804 North Camden Drive

STAFF REPORT
CITY OF BEVERLY HILLS

**For the Design Review Commission
Meeting of November 4, 2010**

SUBJECT: A request for a revision to a previously approved R-1 Design Review Permit to allow a new two-story single-family residence located in the Central Area of the City, north of Santa Monica Boulevard at **804 North Camden Drive.** (PL 090 5850)

Elevation Preliminary Approved – 3/5/09

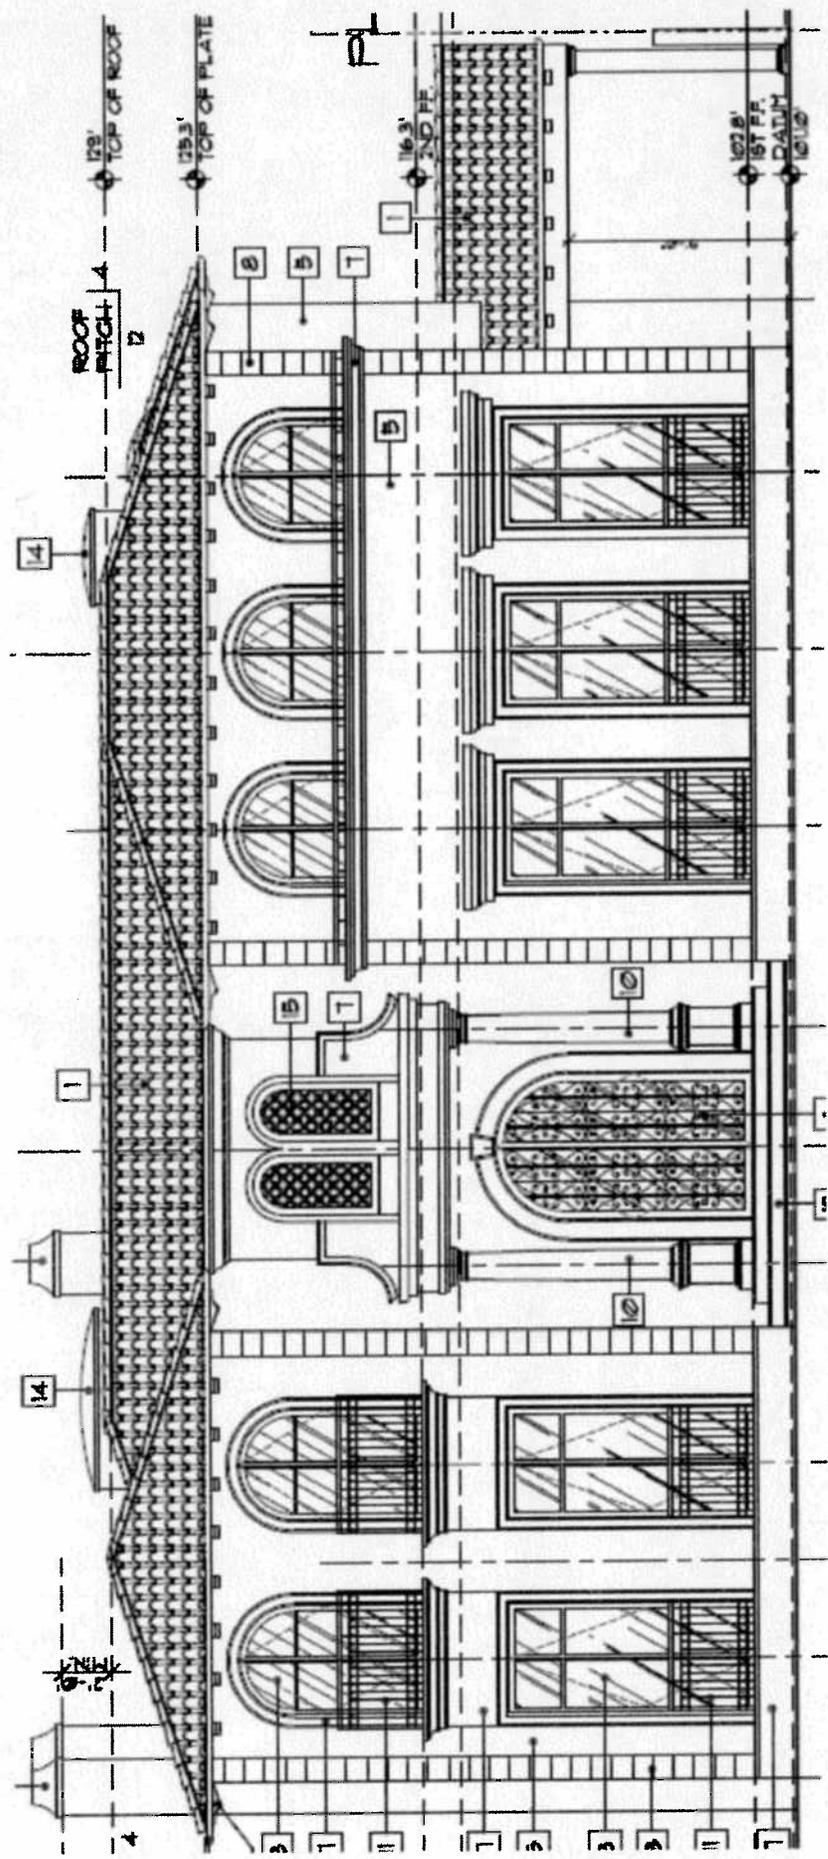
- A detail of the proposed stained glass windows be provided (textured only; no flowers, fruit, etc.);
- A detail of the wrought iron railings along the front façade be provided;

- A detail of the wrought iron fencing and an elevation of the fence be provided;
- A detail of the proposed front door be provided (should be simpler and more elegant);

- The pediments be removed from above the first floor French doors (front façade);
- The first floor French doors be reduced to a maximum of 10' in height;

- The skylights be reduced in height to within the maximum height allowed for the structure (28');
- The balconies along the north elevation (in the recessed portion of the facade) be redesigned as Juliette balconies;

- A trellis be added to the northern portion of the deck/balcony at the rear of the residence to provide further screening and privacy;
- A large tree be planted by the recessed portion of the northern elevation to screen the wall of windows adjacent to the internal staircase (minimum box size 48");

- The carport along the southern elevation be removed and, if desired, be replaced with a porte cochere (as defined by Beverly Hills Municipal Code §10-3-100). A carport is not a permissible encroachment in the side yard (BHMC §10-3-2409).
